UNITED STATES PATENT AND TRADEMARK OFFICE

APPLICATION NO.	FILING DATE	FIRST NAMED INVENTOR	ATTORNEY DOCKET NO.	CONFIRMATION NO.
10/684,792	10/14/2003	James Vlaanderen	00868P0026US	2996
32116	7590	07/18/2005	EXAMINER	
WOOD, PHILLIPS, KATZ, CLARK & MORTIMER 500 W. MADISON STREET SUITE 3800 CHICAGO, IL 60661			ADAMS, GREGORY W	
			ART UNIT	PAPER NUMBER
			3652

Office Action Summary	Application No.	Applicant(s)	
	10/684,792	VLAANDEREN ET AL.	
	Examiner	Art Unit	
	Gregory W. Adams	3652

Claim Rejections - 35 USC § 103

FIG. 1

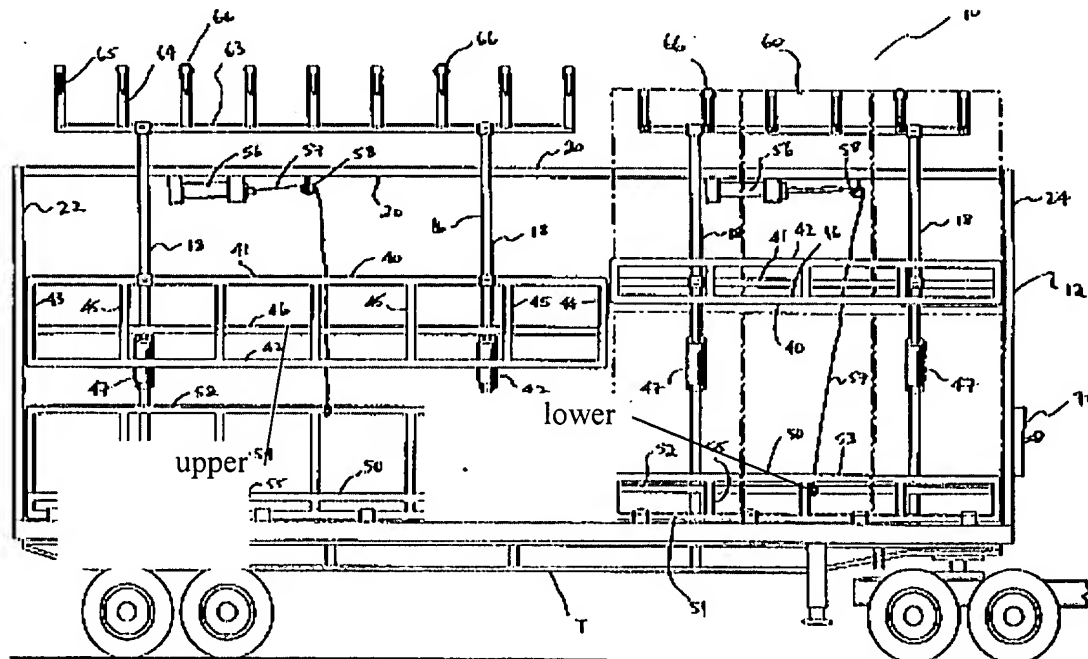
7. With respect to claim 8-9, Babb discloses that lower object supports are shorter than upper object supports (FIG. 1 below), and discloses sharing a first pivot 14. It is

noted that Babb discloses eight (8) object supports such that two (2) lower object supports and linkages thereof share pivot 14, and long links 45 of upper most object support 40 are longer than long links 55 of lowermost object support 50. Babb teaches an apparatus that transports cylindrical objects in rows and tiers, with the ability to pivot rotatably object supports from a loaded position to an unloading position. Para. [0002] – para. [00013]. Therefore, it would have been obvious to one having ordinary skill in the art at the time the invention was made to modify the apparatus of Foote to include shared linkages and object supports which are shorter and longer and longer uppermost long links, as per the teachings of Babb, to transport cylindrical objects in rows and tiers, with the ability to pivot rotatably object supports from a loaded position to an unloading position.

13. With respect to claim 14, Babb discloses that lower object supports are shorter than upper object supports (FIG. 1 below), and discloses sharing a first pivot 14. It is noted that Babb discloses eight (8) object supports such that two (2) lower object supports and linkages thereof share pivot 14, and long links 45 of upper most object support 40 are longer than long links 55 of lowermost object support 50. Babb teaches an apparatus that transports cylindrical objects in rows and tiers, with the ability to pivot rotatably object supports from a loaded position to an unloading position. Para. [0002] – para. [00013]. Therefore, it would have been obvious to one having ordinary skill in the art at the time the invention was made to modify the apparatus of Foote to include shared linkages and object supports which are shorter and longer and longer uppermost
